5 May 2021
Ref 20355

SSD 8859
PROPOSED SUBDIVISION
1111-1141 ELIZABETH DRIVE, CECIL PARK
SITE ACCESS MATTERS

Road Safety Audit Report

Proposed Development at 1111-
1141 Elizabeth Drive, Cecil Park
(SSD-8859)

DRAWING TITLE
19M SEMI-TRAILER TURNING PATH
Entering/Exiting Proposed Access Road

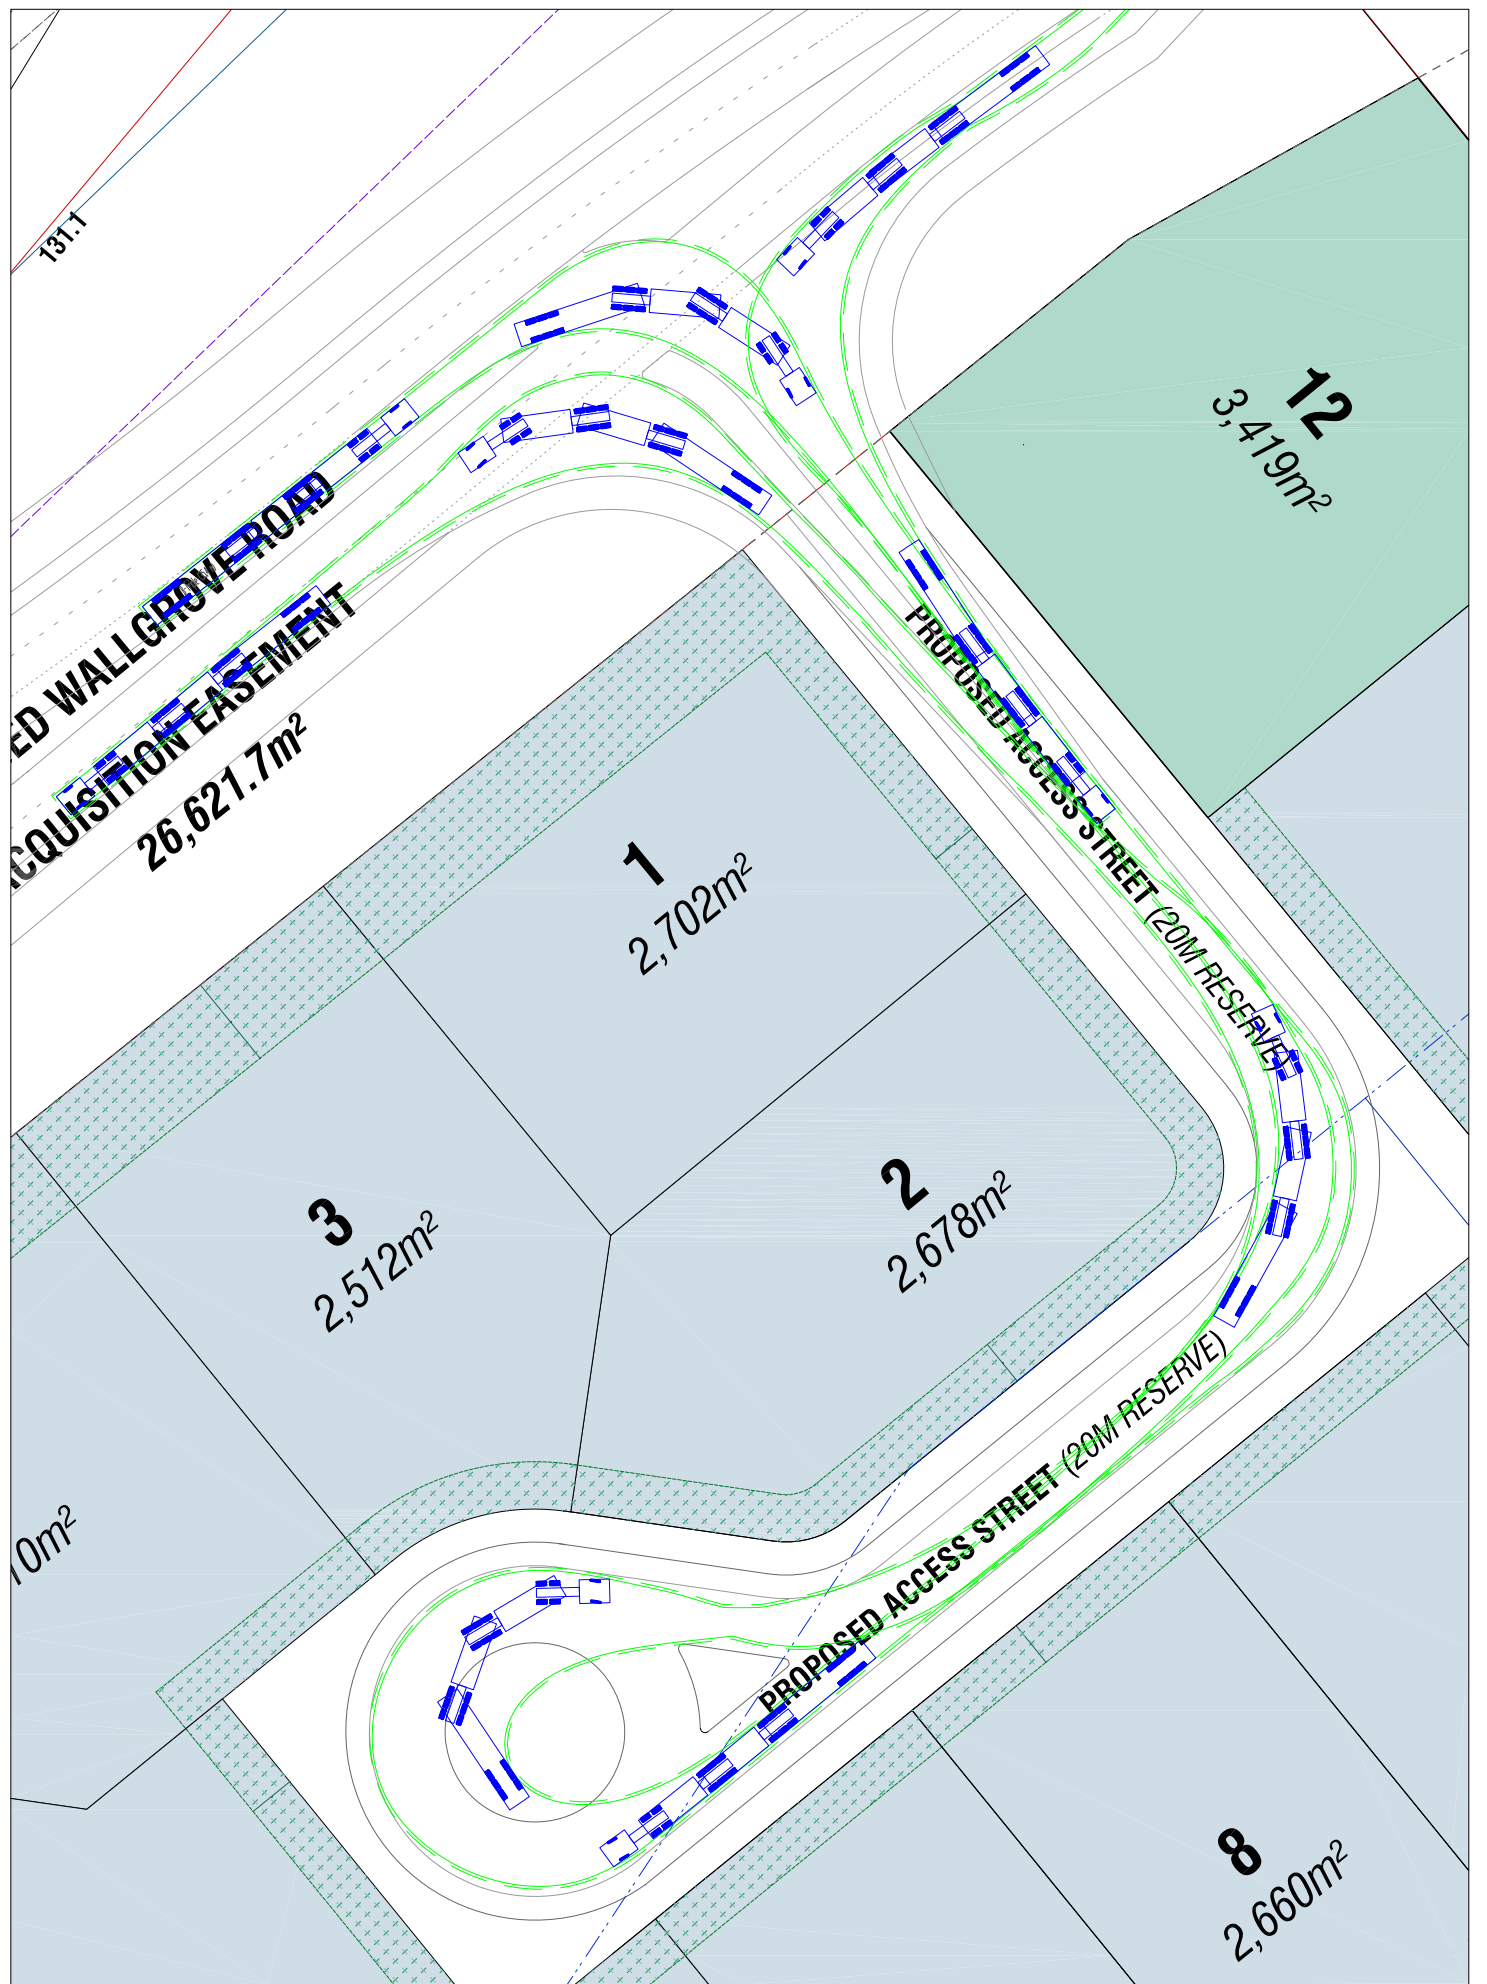
- a. Realigned Wallgrove Road / new site access road
 - b. Realigned Wallgrove Road / Cecil Road
 - c. Realigned Wallgrove Road / Elizabeth Drive
5. A swept path analysis for the largest vehicle accessing the site should be provided.

Please see attached the swept turn path of the longest vehicles that are anticipated to access the proposed subdivision, as follows:

- Design vehicle: 19m articulated semi-trailer
- Checking vehicle: 35m B-Triple
